ADDENDUM #1

A. Project Number: 15-STA-512
B. Project Title: Plaza Upgrade
C. Project Location: 701 W. Riverside Ave, Spokane, WA
D. Owner: Spokane Transit Authority

ADDENDUM # 1

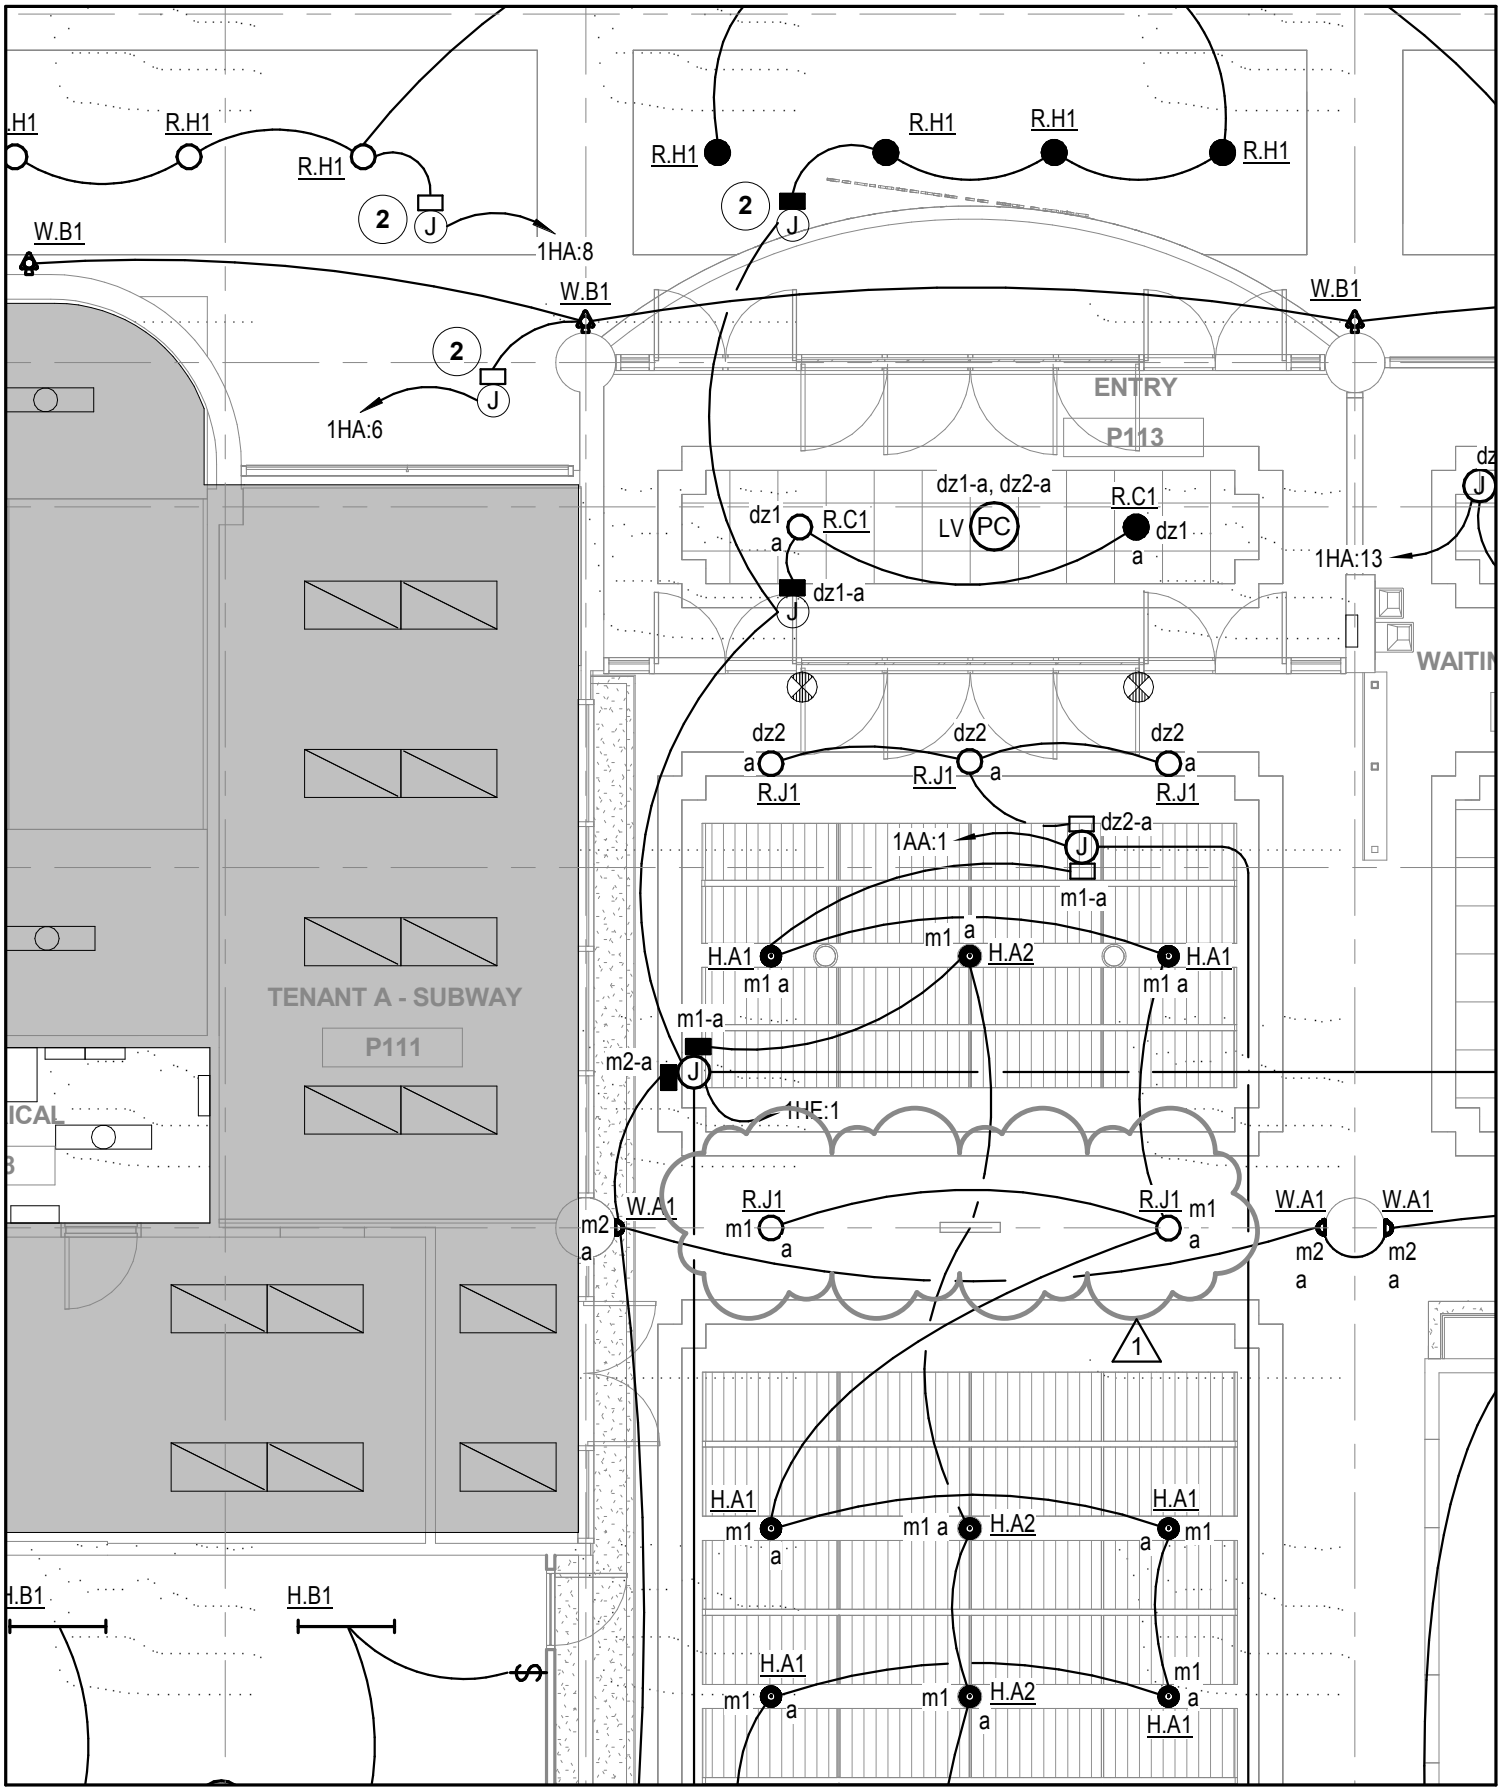
35.	Sheet S-201, detail D1, D5, & D6	REVISE Clock Tower framing to chevron configuration at all bays; reference sketches S-04 & S-05
36.	Sheet E-102	Changed luminaire type between clouds to RJj1, refer to sketch E-01

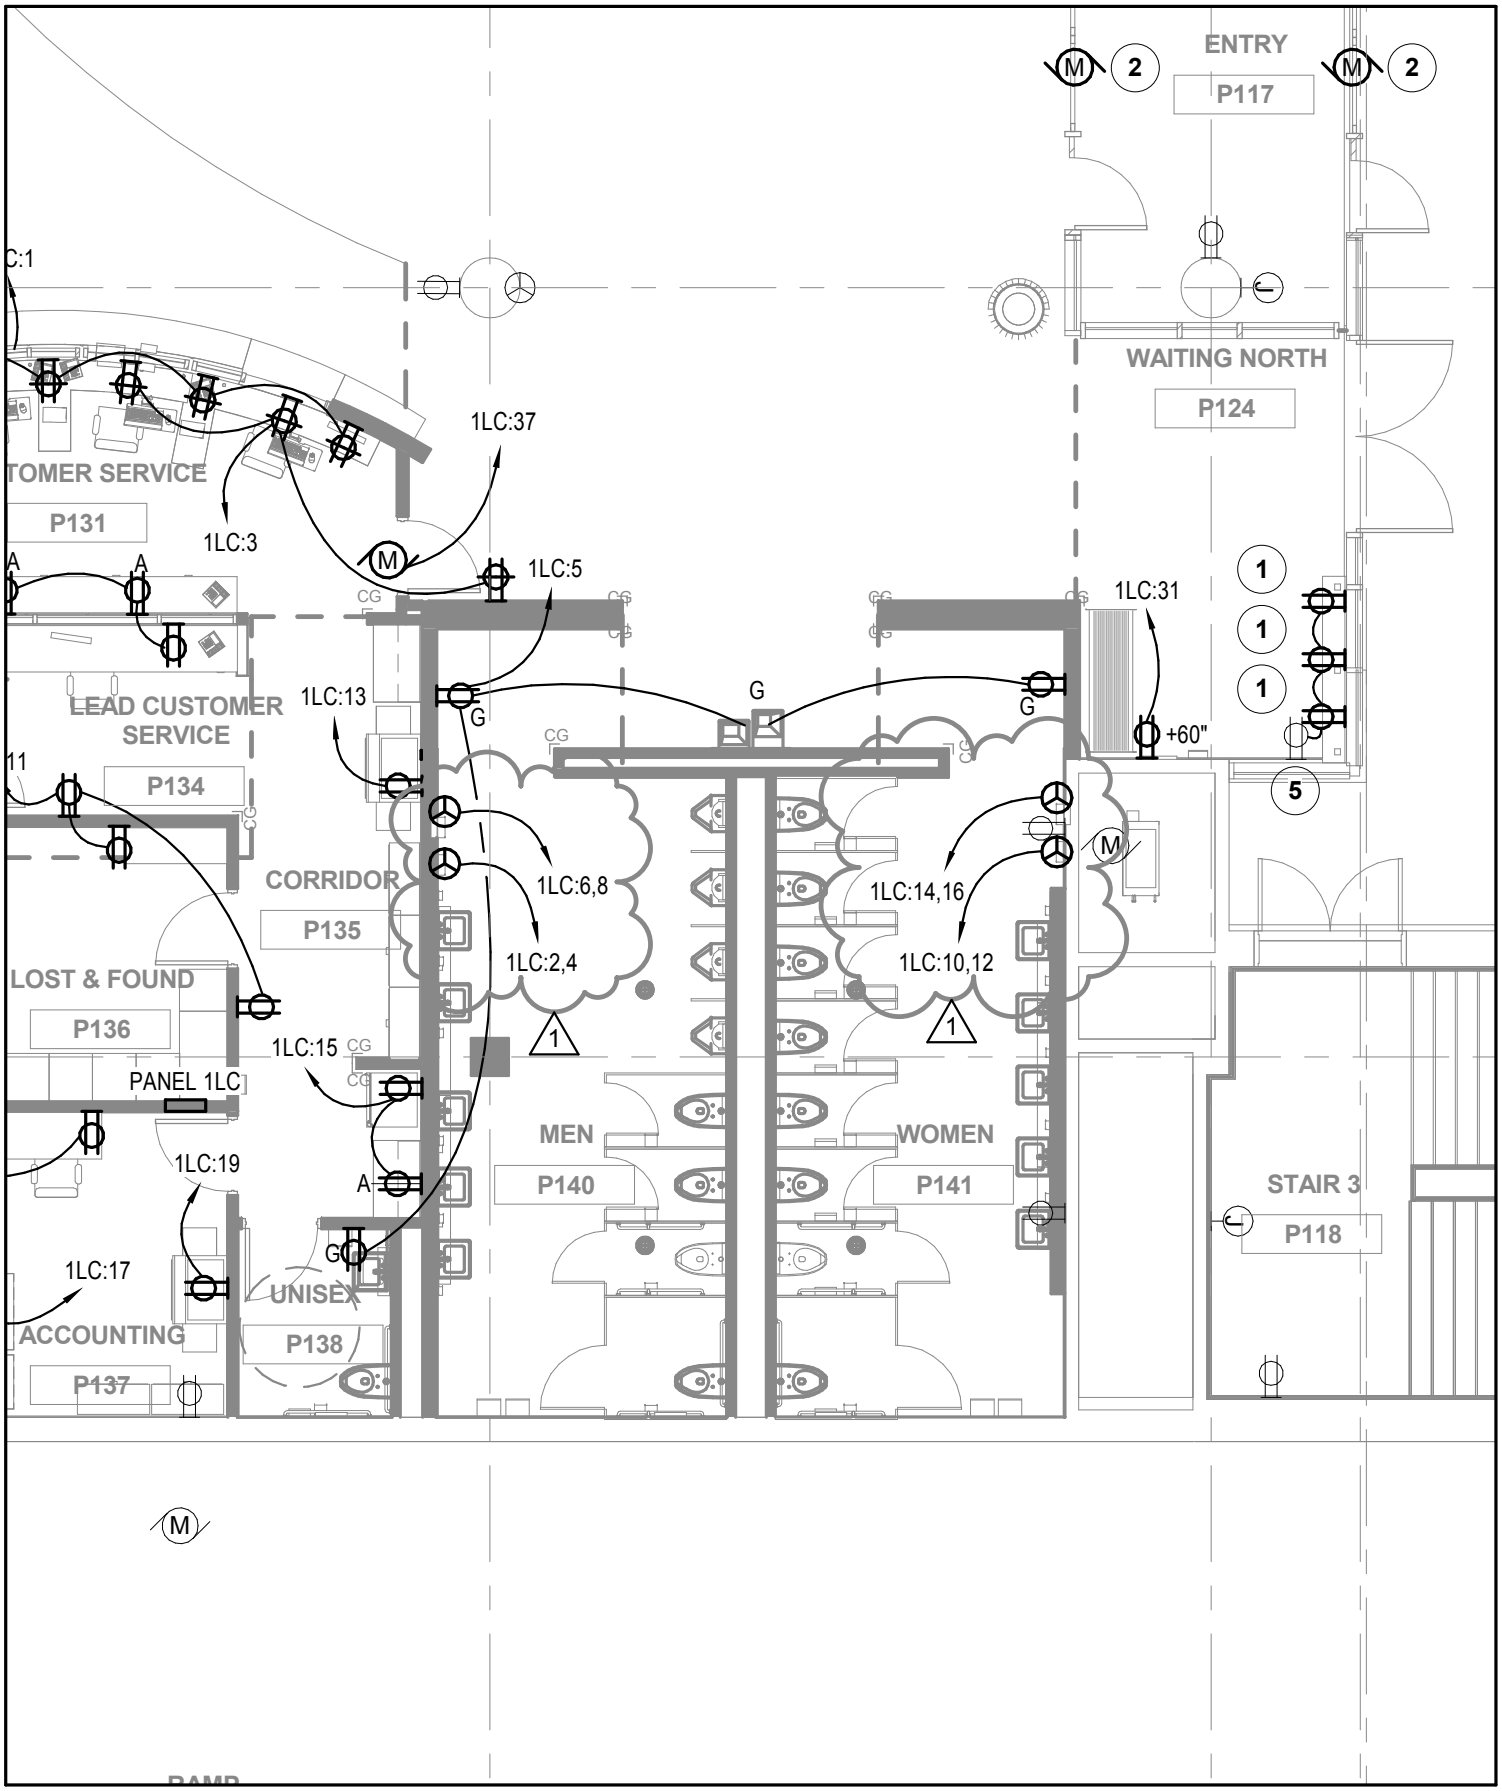
45.	Sheet E-112	Add a second equipment connection for hand dryers in both restrooms P140 and P141. Refer to sketch E-10.
46.	Sheet E-701	Revised Part # for luminaire type R.A1 to reflect 2000 lumen output. Revised part # 2VTL2-20L-ADP-EZ1-LP835.
